## Product Change Notification: CAAN-30ZFJS110

CCB 7729 Final Notice: Qualification of a new lead frame with more Ag area on DAP surface prep for selected KSZ8051, KSZ8081 and KSZ8091 device families available in 32L VQFN (5x5x0.9mm) package.

PCN#: CAAN-30ZFJS110

# Pre and Post Change Summary

## Pre Change

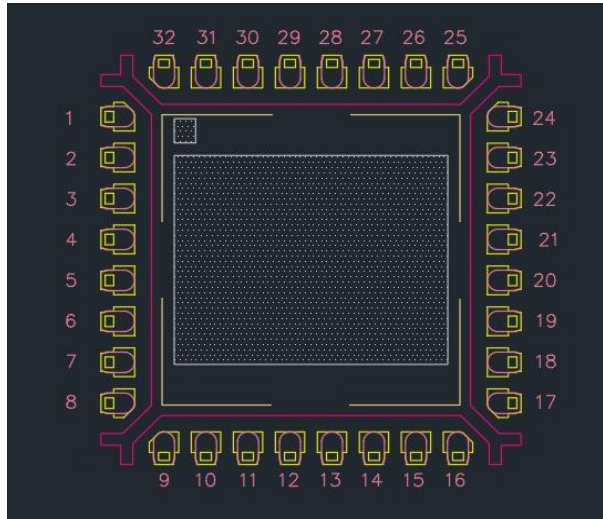
Lead-frame Material	A194
DAP Surface Prep	Ag selective

## Post Change

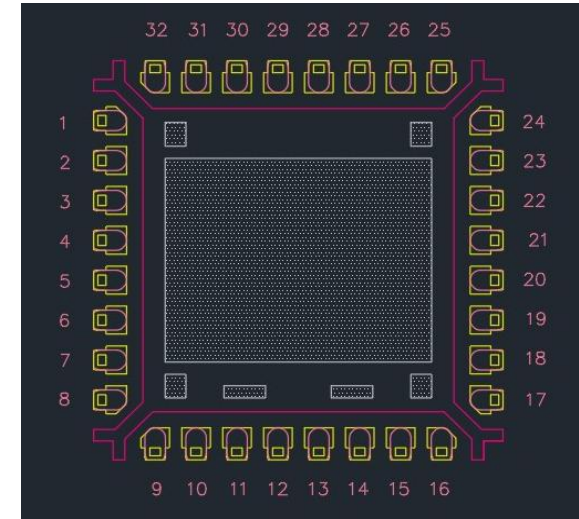
Lead-frame Material	A194
DAP Surface Prep	Ag selective (Add more Ag area)
